**RE: Applicability of the NC Residential Code for Multiple Detached One- and Two-Family Dwellings on a Single Lot  
2018 NCAC Section 101.3.2.1**

**RE: Request for Formal Interpretation for Cape Cottages, Leland NC**

**WESTGATE COTTAGES**  
 TOWN OF LELAND, NC

**ASSUMED LOT LINES**

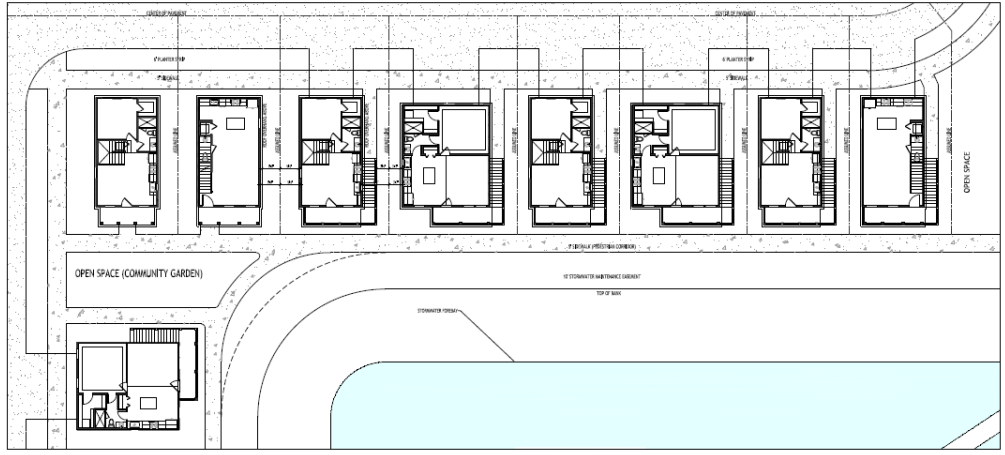
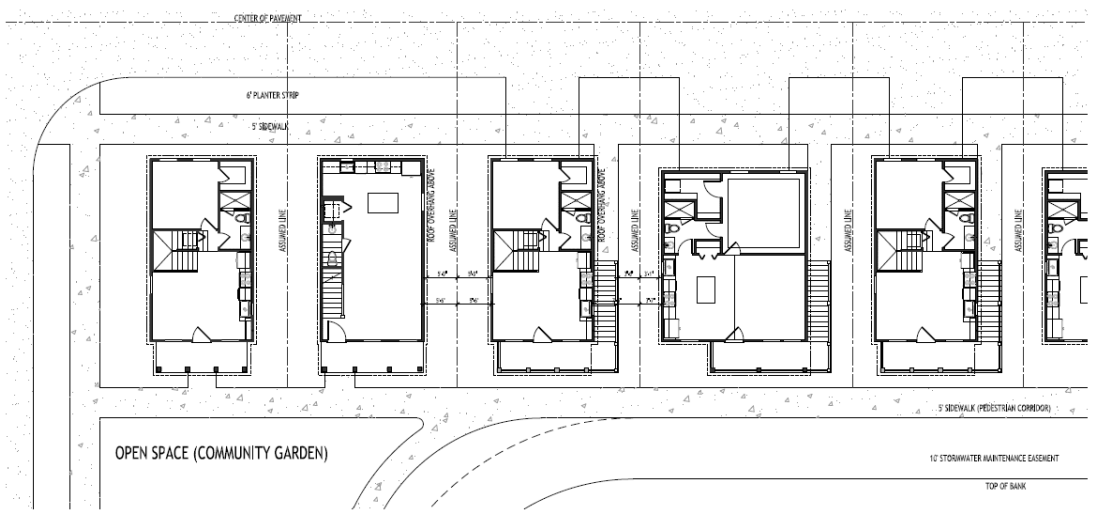
In the email chain dated July 30th, 2021 Mr. Pak Yip offered his opinion that the NCRC is intended for a maximum of 1 two-family dwelling on a site or a 2 single-family dwelling on a site, and that if it has more it is expected to be constructed under the provisions of the NCBC as Group R-3 dwelling unit. He went on to say that the NCRC does not address 'assumed property lines' and does not expect one-two family dwelling on a single lot, but that the NCBC does.

We disagree with this opinion since it appears that both the NCBC and the NCRC address imaginary separation lines between buildings in the definitions chapter of both code books. Both the Building Code and the Residential Code have the same definition for Fire Separation Distance and include language for an imaginary line between buildings on the same lot.

Since accessory buildings already have an exception for the fire resistant rating when located on the same lot (see Residential Code R302.1 Exception2), that would suggest that the imaginary line would be intended to be between different dwellings on the same lot. Additionally, when the NCRC requires soffit protection (see R302.1.1 Exception 4), it provides an exception for soffits between buildings located on the same lot. Again, this would suggest that multiple separate one-family dwellings on the same lot can be expected and is acceptable under the provisions of the NCRC.

1. The dwellings appear to be detached single-family dwellings 3-stories or less in height which the NCRC would allow if there were only one such dwelling on the site and as would be allowed by the NCBC for multiple such dwellings on a site.

4. The NCRC is not a standalone code. It functions in conjunction with other NC State Building Codes. As shown in the “Code Analysis” section above, the NCBC is expecting to control the construction of multiple one- and two-family dwellings and townhouses located on a single parcel of land. The NCBC then allows use of the NCRC for multiple detached one- and two-family dwellings and townhouses on a site with limits regarding separation of buildings or

automatic fire sprinkler systems. The result is that the NCRC is limited to a single one- or two-family dwelling on a parcel of land unless the building separation or automatic fire sprinkler system requirements of the NCBC are met. The definition of “townhouse” in the NCRC limits townhouses to a single dwelling unit on a parcel of land.

- a. The NCRC allows the construction of a single detached one- or two-family dwelling or a townhouse on a site along with multiple accessory buildings and structures. According to NCRC, Section 302.1, exception #2 there is no separation requirement between a dwelling and the associated accessory buildings on the same lot; so, “imaginary separation lines” become a nonissue.
